Wylfa Newydd Project

Horizon's Deadline 8 Responses to Stakeholder Deadline 7 Submissions

PINS Reference Number: EN010007

25 March 2019

Appendix 1-1 Extended operational photomontage for Viewpoint 27

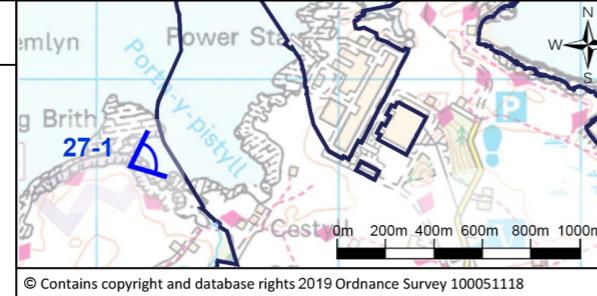
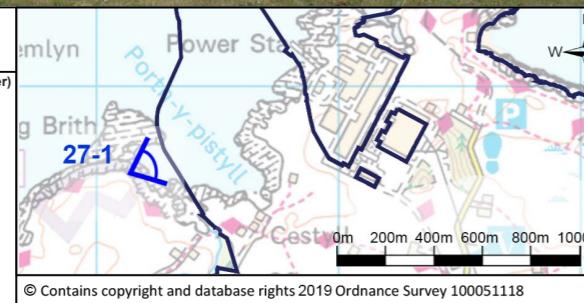
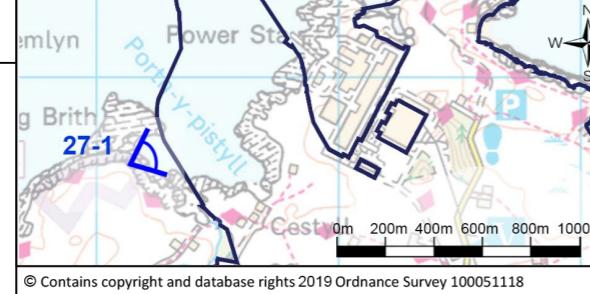
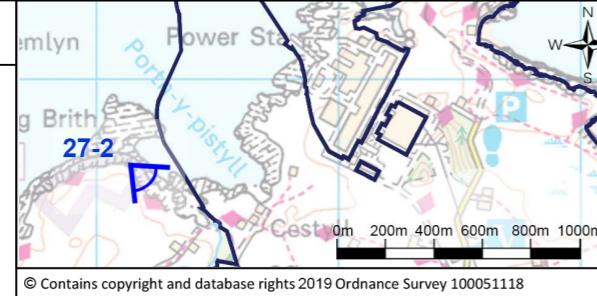
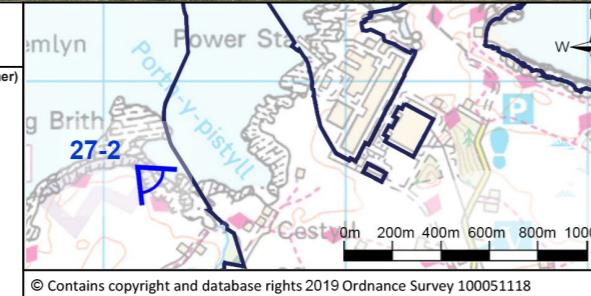
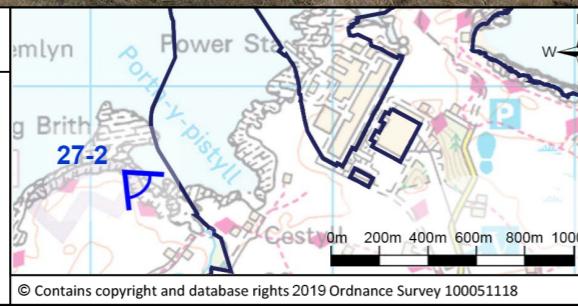
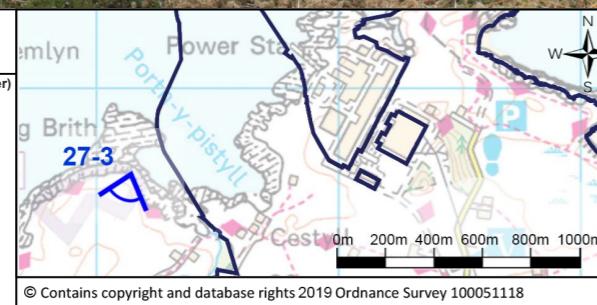
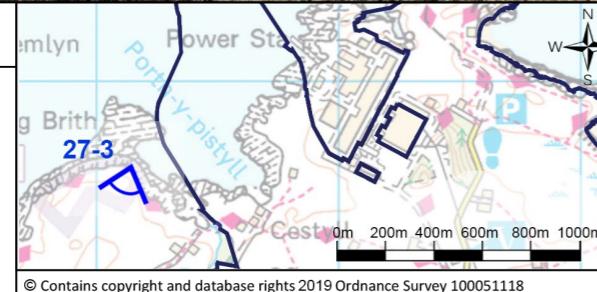
1.2.2 The National Trust comment on the operational photomontage viewpoint 27 in appendix D10-8 of the DCO ES [APP-199] that “*We still do not have an operational photomontage to illustrate the development in relation to the heritage assets when viewed from this location.*”

Although the operational photomontages provided in appendix D10-8 of the DCO ES [APP-199] only illustrate an 80 degree horizontal angle of view, the visual effects of the proposed development are described in full at appendix D10-7 of the DCO ES [APP-198]. However, to address this comment Horizon have provided an extended version of the operational photomontage view from Viewpoint 27 in appendix 1-1 of this response.
